County of Fairfax, Virginia

STAFF REPORT

SPECIAL EXCEPTION APPLICATION SEA 87-D-025 WAIVER #6713-WPFM-001-1

APPLICANT: Vinson Hall Corporation

SCALE: 1" = 100'
 DATE: MAY 20, 2009
 SHEET: 4 OF 6

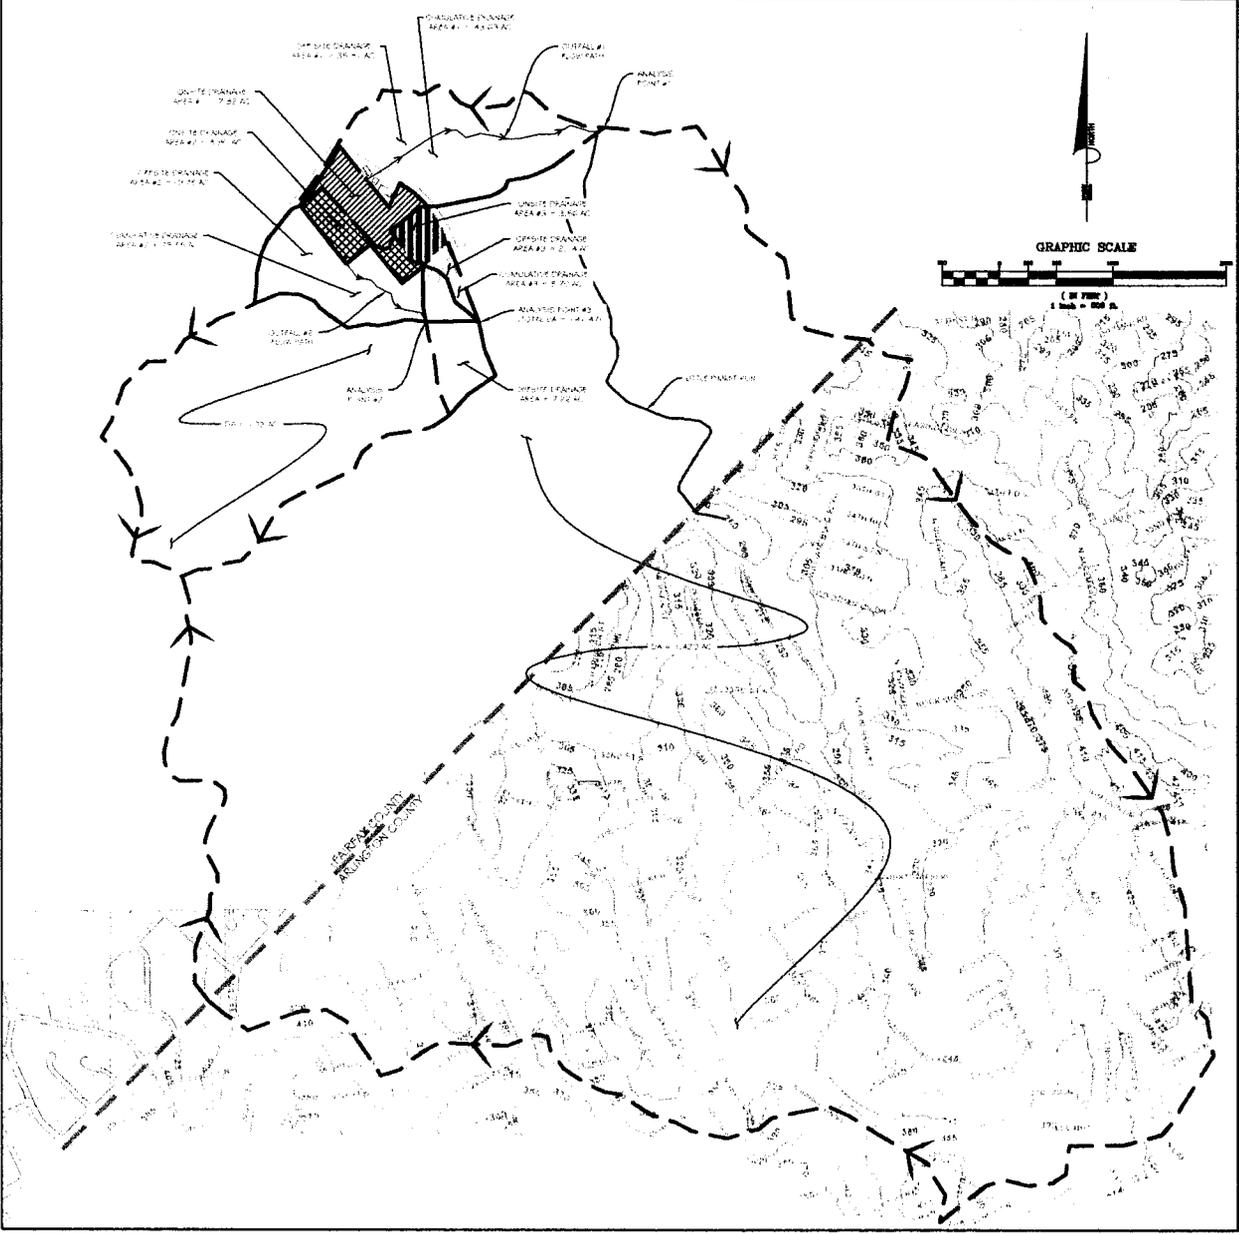
The previously submitted SEA Plat indicated that the existing on-site SWM pond would be enlarged and retrofitted as a BMP facility. In addition to the existing Filterra unit on the site, the applicant also proposed to install a bioretention filter. Possible additional Filterra units were shown to be provided in the western portion of the site if required at site plan review in order to satisfy the BMP

The applicant has revised the SEA Plat to depict an underground storage facility that would be 60 inches in height, as recommended by DPWES. Furthermore, the applicant has provided information to DPWES staff to demonstrate that the existing pond would be enlarged by further excavating the existing pond in order to adequately serve the southwestern portion of the site. Based on these changes, DPWES is now recommending that the Board of Supervisors approve the waiver request to permit an underground storage facility in a residential development. Therefore, staff believes that these issues have been addressed.

As previously noted, the applicant has revised the SEA Plat to demonstrate that the existing pond would be enlarged by further excavating the existing pond in order to adequately serve the southwestern portion of the site. Based on the revisions made to the SEA Plat, staff believes that this issue has been addressed.

SCALE: 1" = 50'
 DATE: MAY 22, 2009
 SHEET 7 OF 9

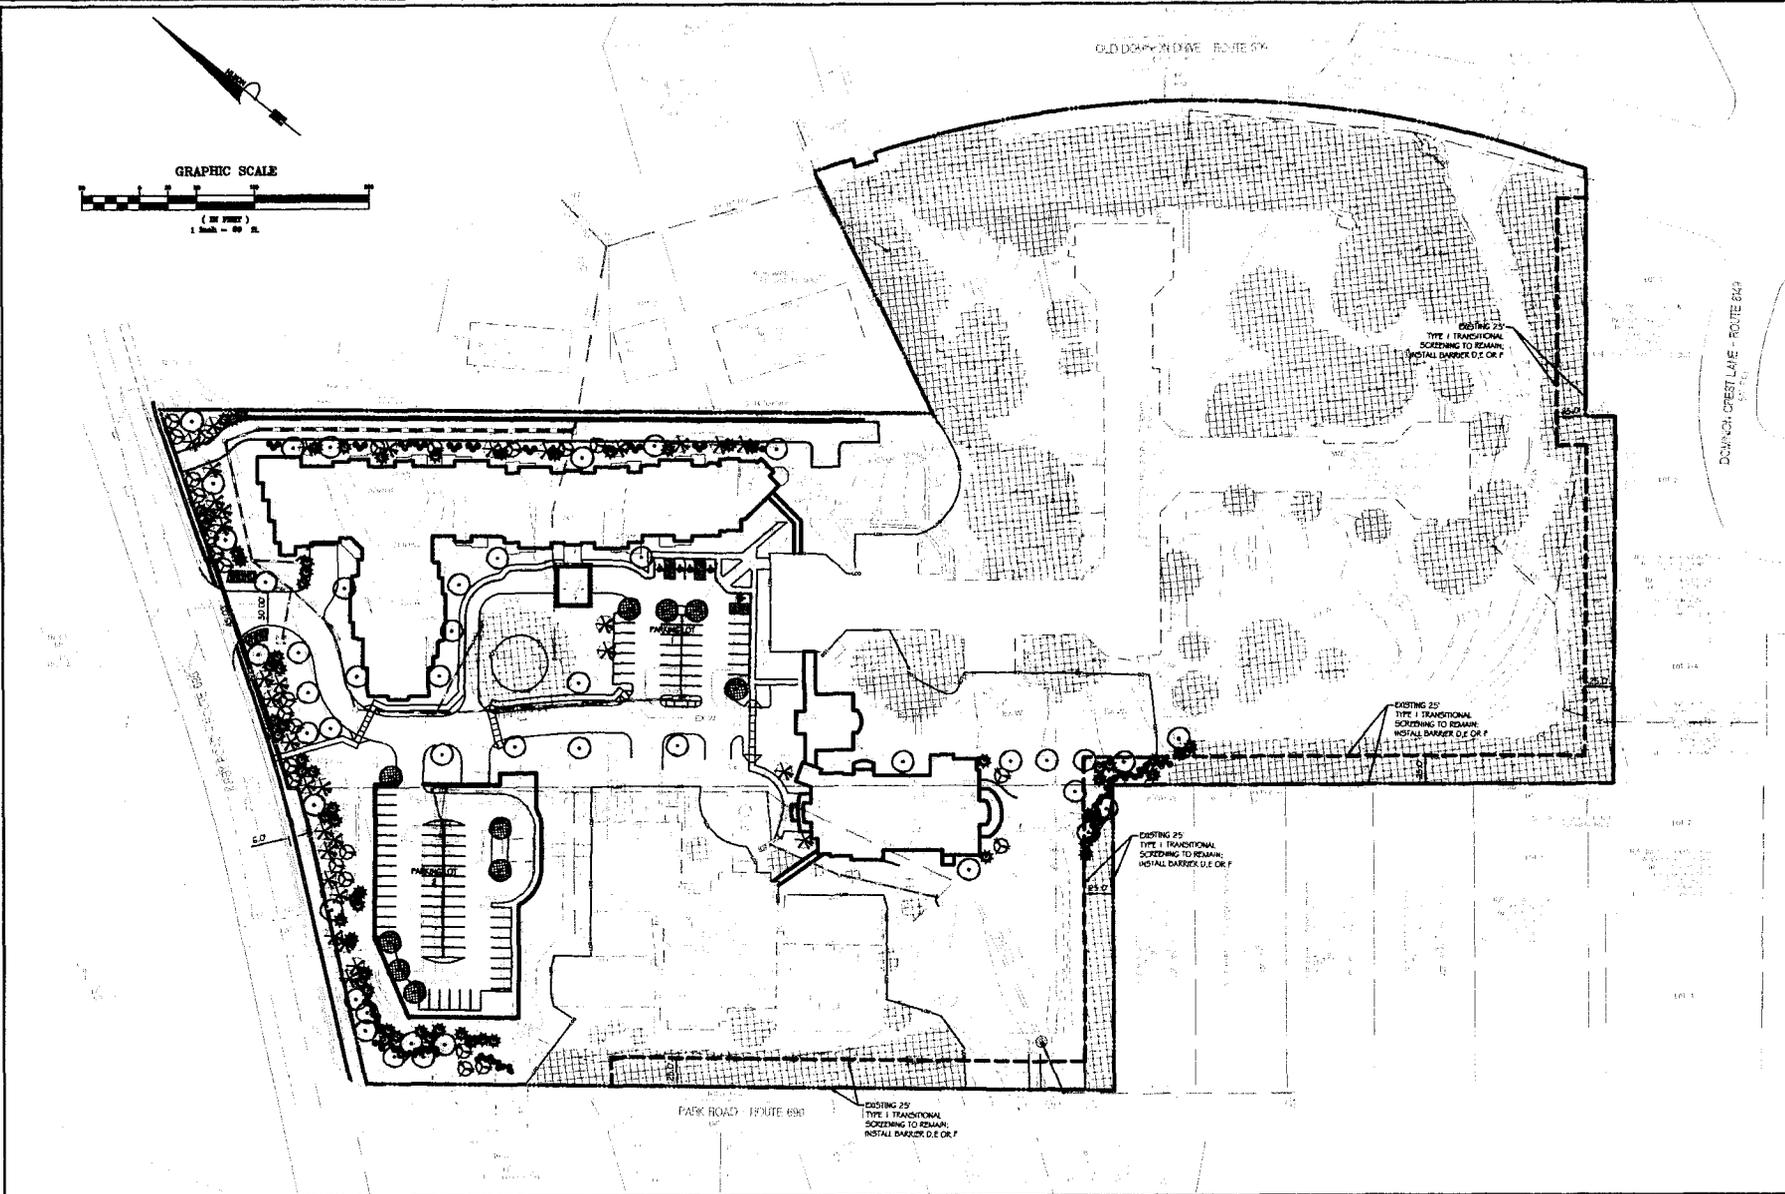
In its review, Urban Forest Management Division (UFMD) staff noted that the SEA Plat depicted trees that appeared to be planted within utility easements. UFMD recommended that all of the proposed landscaping be located outside utility easements and at least five feet away from storm drainage easements containing pipes.

Urban Forest Management Division (UFMD) staff indicated that the SEA Plat did not contain parking lot landscaping calculations. Without this information, UFMD could not evaluate if the interior parking lot landscaping requirements would be met. As such, staff recommended that the calculations and illustrations for interior parking lot landscaping be provided on the landscape plan submitted with this application.

The applicant has revised the SEA Plat accordingly to ensure that the proposed landscaping is located outside utility easements and at least five feet away from storm drainage easements containing pipes. Therefore, this issue has been addressed.

The applicant has revised the SEA Plat to include the interior parking lot landscaping calculations and illustrations with the landscape plan. Based on this information, staff has determined that the interior parking lot landscaping requirements for the site will be met. Therefore, this issue has been addressed.
